Delmore Fast-Track

04/05/2026 – Auckland Council Response

Annexure 13:

Re: Wastewater Response Memorandum

Figure 1 – Concept design of the infiltration trench used to provide land contact to discharges prior to entry into the unnamed tributary. (Calthom Consultants, 2021)

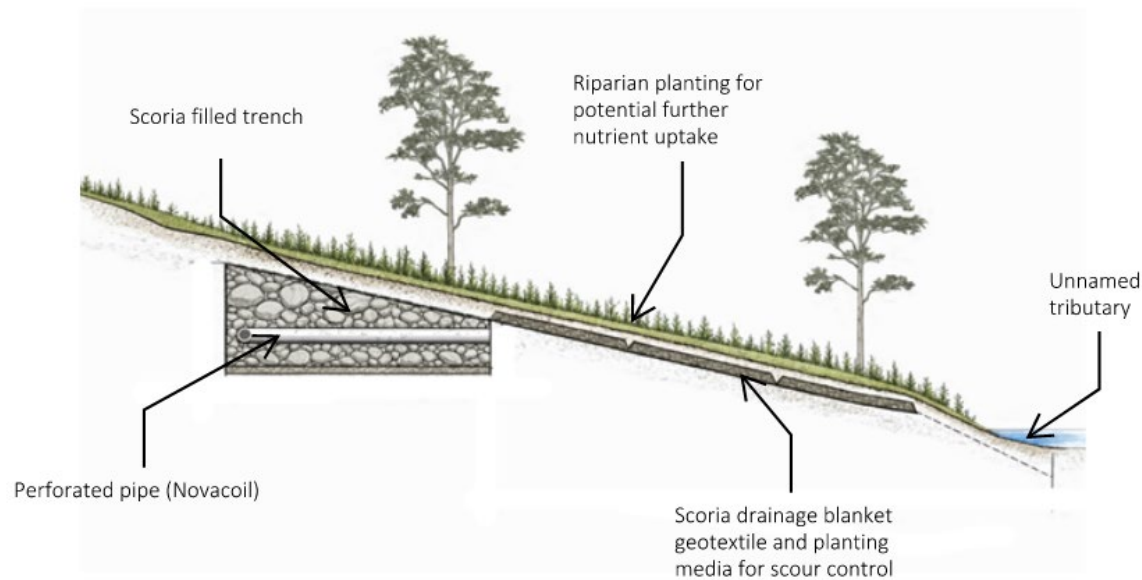
Information Request from Council on the lodged material	Applicant Response	Council Specialist Response
No concept design for wastewater disposal trench has been provided.	Apex: A concept design for the treated effluent disposal trench is attached as Appendix A .	Accepted
No concept design for wastewater irrigation field has been provided. A detailed design is not required, but the level of information on the disposal field currently provided is not sufficient.	Apex: A concept design for the wastewater irrigation field is attached as Appendix B .	Accepted
No field investigation (hand augers or surface assessment) for proposed disposal field.	Riley: Across the site we have drilled 85no. hand auger boreholes, excavated 53no. test pits and drill 6no. deep machine boreholes. A number of them are near or immediately adjacent to the areas identified for effluent disposal. Overall, we consider that the number and spread of the investigation test locations provides an appropriate level of coverage for assessment of the soil soakage category for the site in terms of GD06.	Accepted

A concept design for a treated effluent disposal trench was designed by Calthom Consultants for the Karaka North Village land development project and has been shown in the figure below. The concept that this trench design is based on is well suited to the Delmore site as it does not rely on infiltration through the native soils but rather provides a naturalised and discrete discharge pathway allowing flows to enter the local unnamed tributary.

The trench consists of two separate parts, (i) the trench itself and (ii) the drainage blanket that extends from the edge of the trench down to the edge of the unnamed tributary. When the underlying soils are unable to assimilate flows into the trench, it shall overfill beneath the surface before diverting down through the drainage blanket. The drainage blanket, installed beneath the surface as a part of riparian improvement works provides a naturalised discharge pathway

The figure below shows a conceptual design for this infiltration trench and drainage blanket. Site topography, slope stability and various other geotechnical considerations will be confirmed prior to detailing a suitable design for construction.
